08-AFC-8A

Re: Notice of Incomplete Application
Project Number: S-1121903

**Subject: Hydrogen Energy California (HECA) – Notice of Incomplete Application
Project Number S-1121903**

PROCESS FLOW DIAGRAM
COAL/COKE STORAGE & RECLAIM SYSTEM

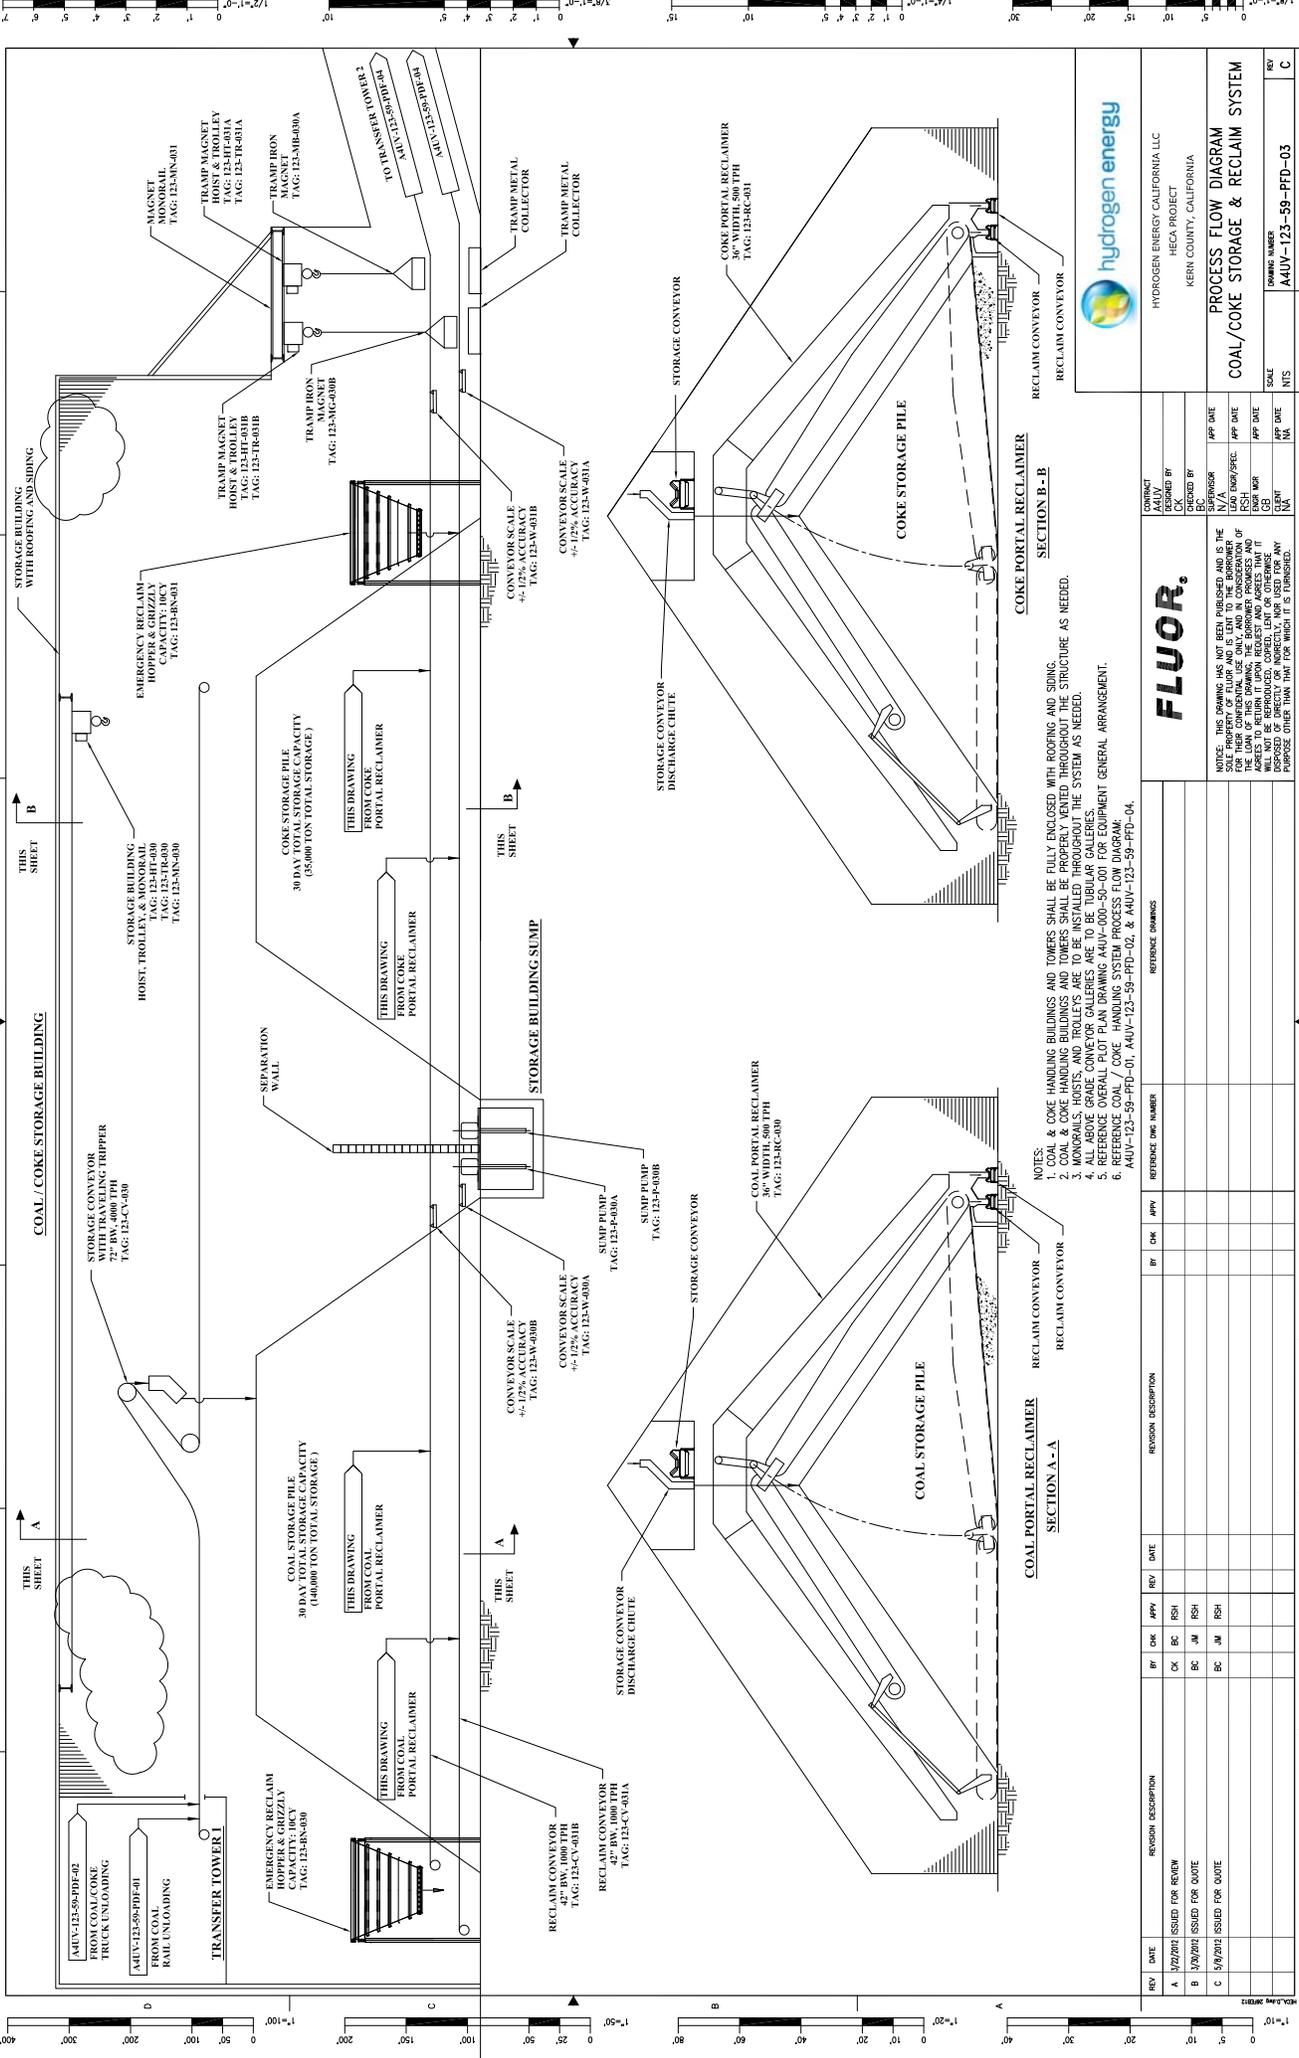
3. Provide process flow diagrams that depict the flow of the dry materials and the process location of the various baghouses.

Attachment 4 contains the process flow diagrams (PFDs) for the material handling systems. The PFDs show six baghouses exhausting to outside ambient air. Because these PFDs reflect recent project refinements, there are fewer baghouses than described in the permit application. The locations of these remaining baghouses are depicted on Figure 1-2, HECA Plot Plan with Emission Source Locations, in the permit application. The baghouses match the source numbers in the table below.

Baghouse Location	Plot Plan Source Number
Coal rail unloading	17
Coal/coke truck unloading	20
Coal/coke crushing building	19
Milling and drying building	Next to gasification block
Gasification solids loadout	29
Urea loadout	23
